Colorado Springs, CO

Final Report - Corrections Required **Application No. DEPN-26-0063**

Description : Single Family Detached residential development located north of New Life Drive in the Flying Horse Master Plan

Document Filename : DP Creekridge at Flying Horse Filing No 1.pdf

DEVELOPMENT PLAN
PRELIMINARY UTILITY & PUBLIC FACILITIES PLAN

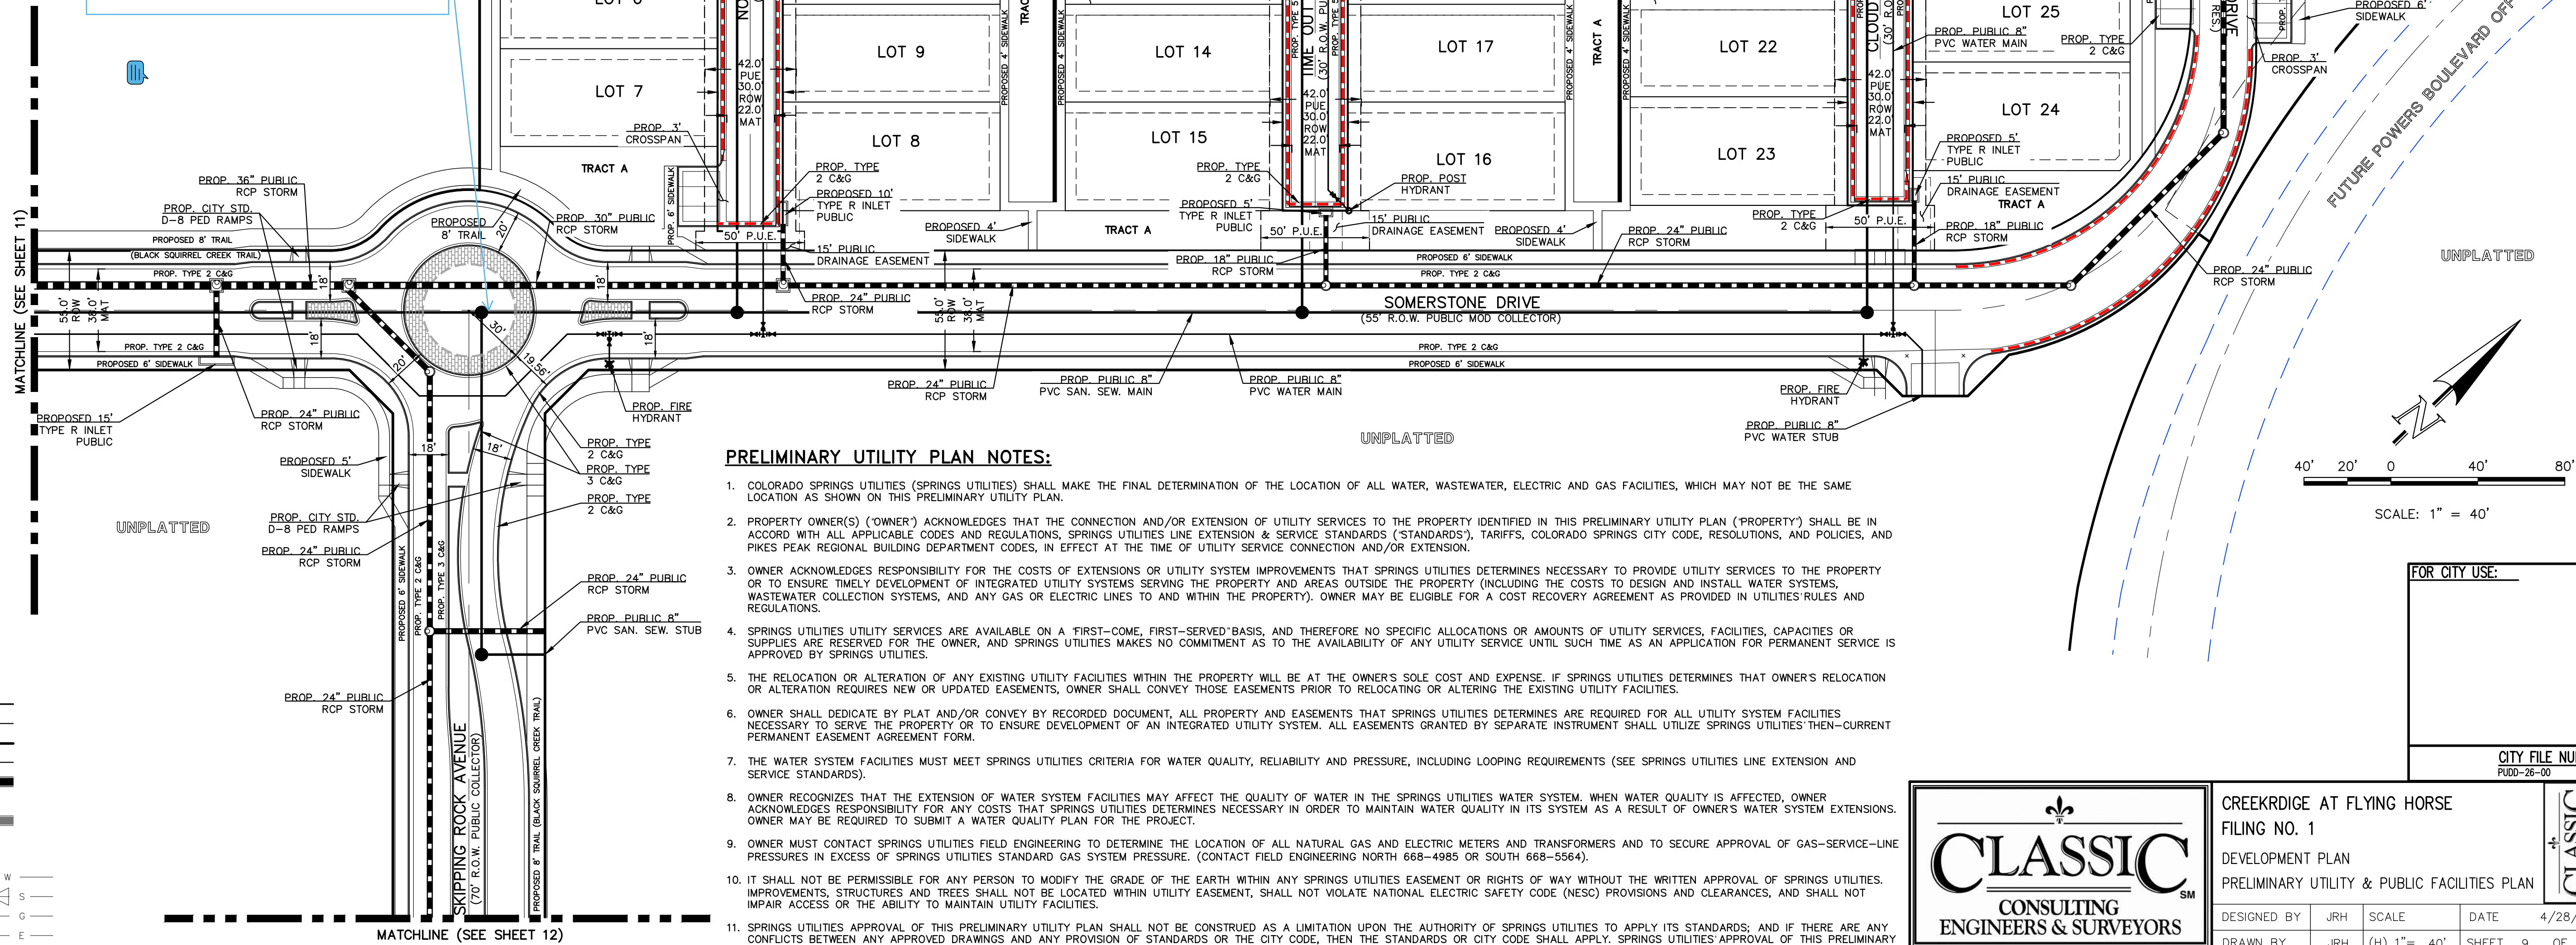
Per WWLESS 2.5.F.5 Crossing Roundabouts and Medians: Manholes may be located within a roundabout or median but they must be accessible by Colorado Springs Utilities for operation and maintenance of the Wastewater System per Section 2.5.D.5. Please provide a maintenance access road per Detail C2-11.

JOB NUMBER	2787-0326
DATE	5/5/2026
DRAWN BY	MB
DRAWING DESCRIPTION	PRELIMINARY LANDSCAPE PLAN - BUILDING TYPICALS
SHEET #	L-9 23 of 23

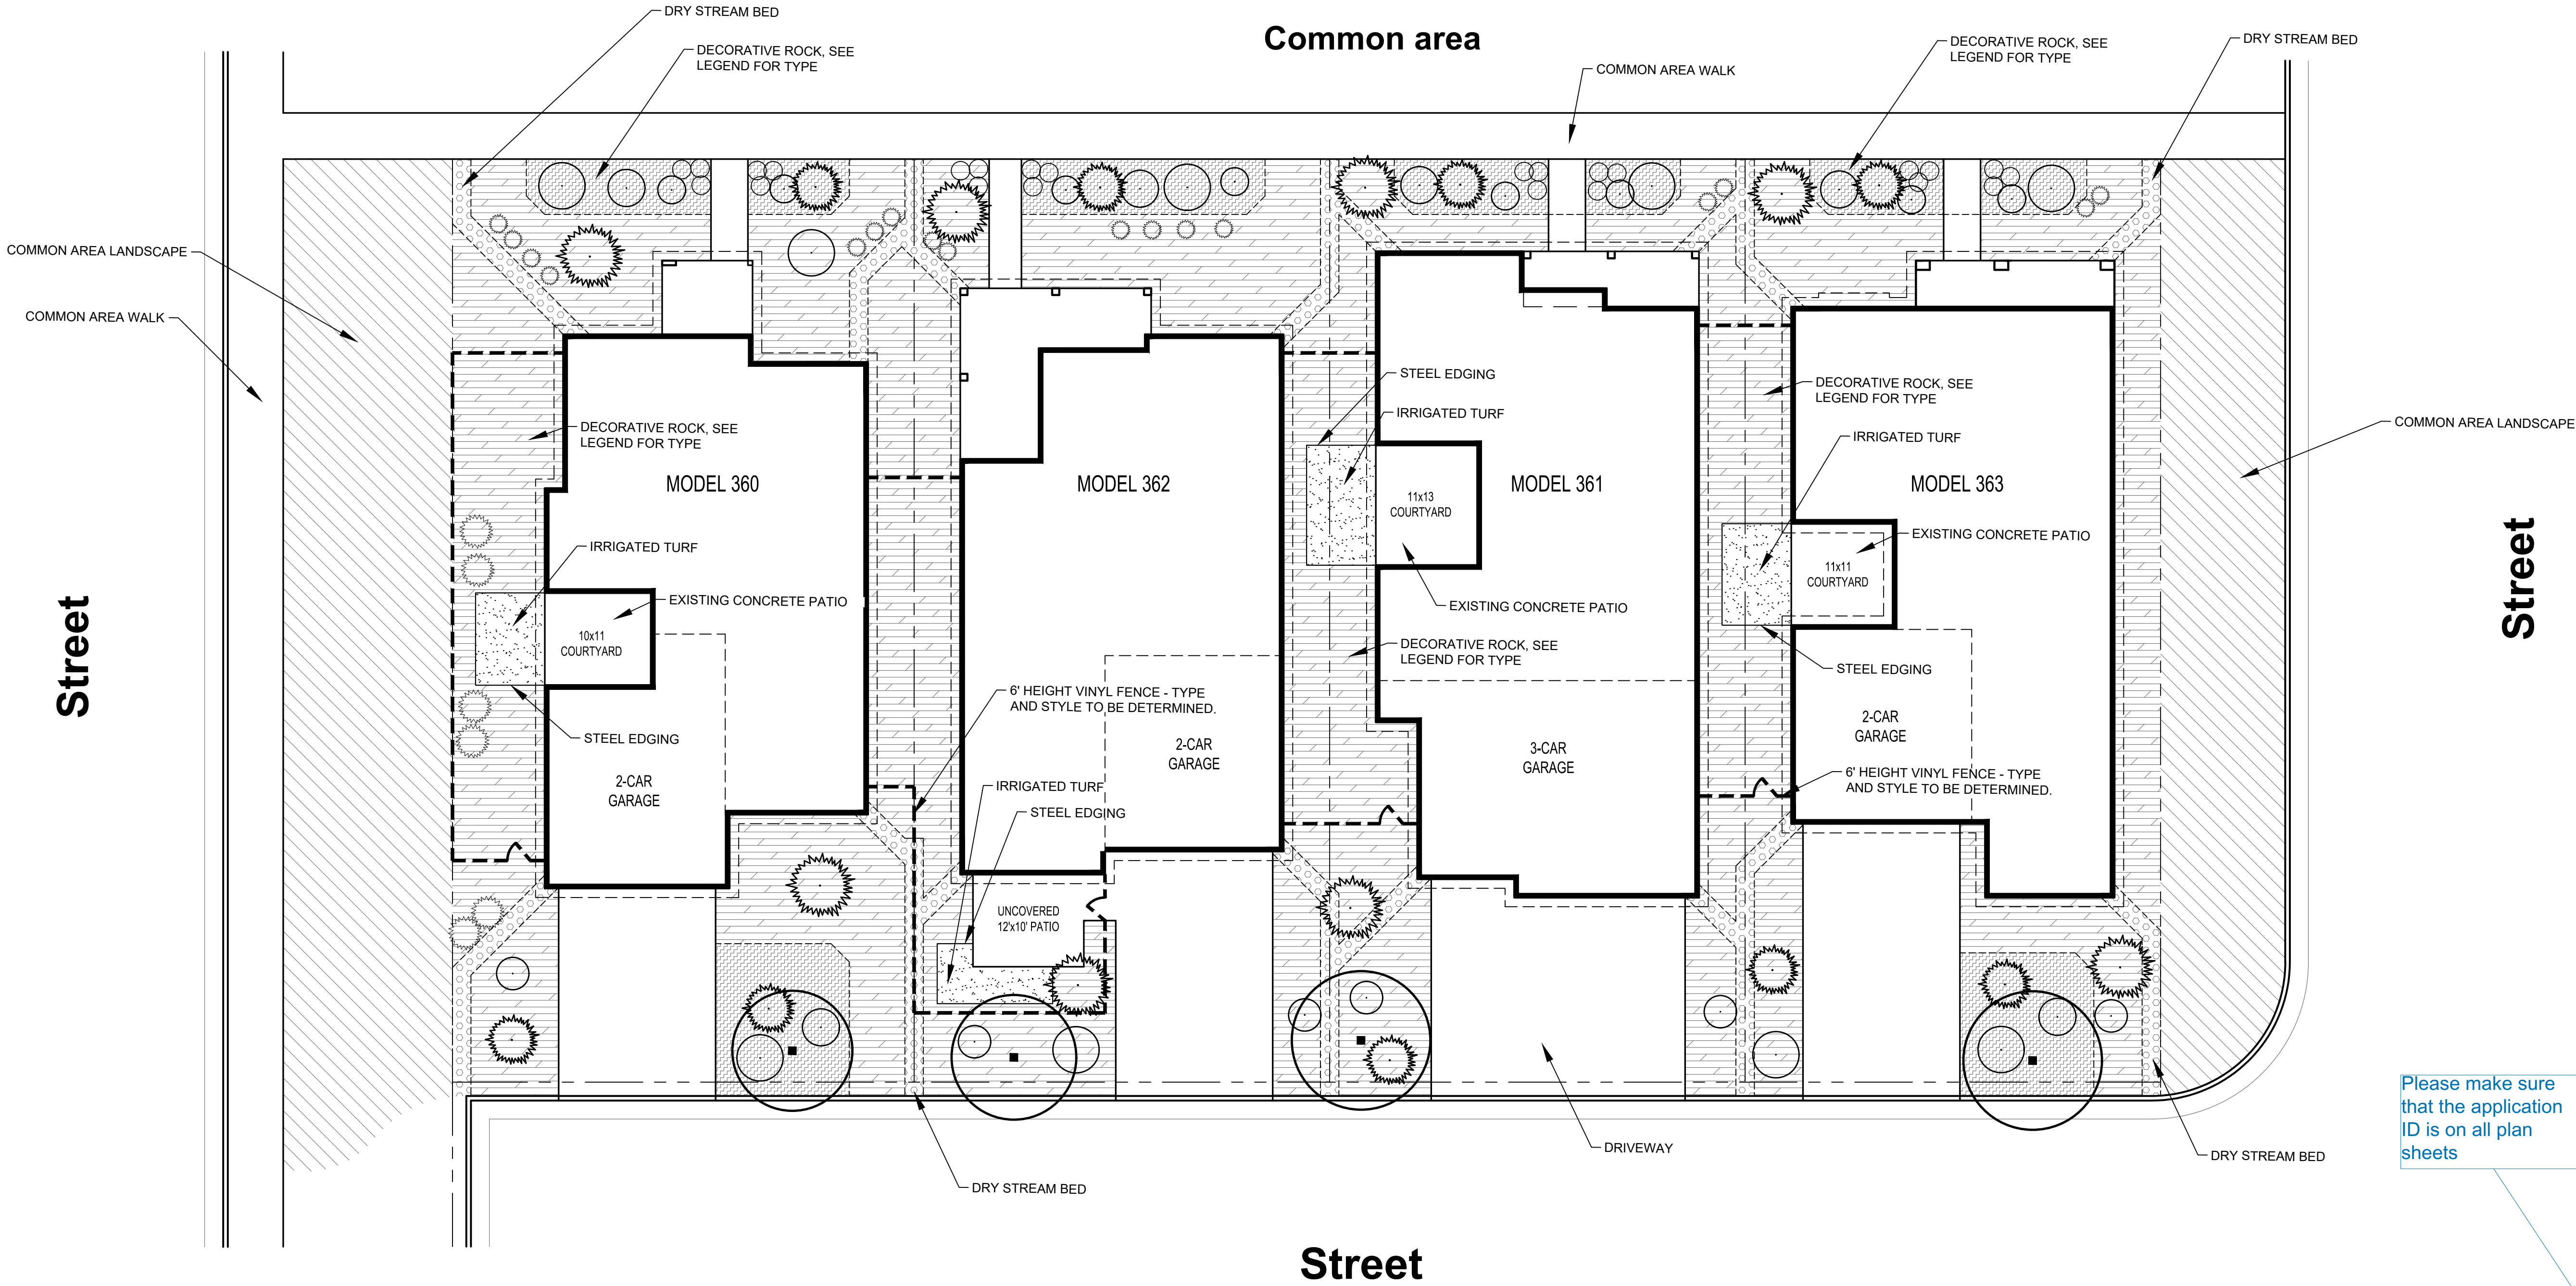
Please make sure that the application ID is on all plan sheets
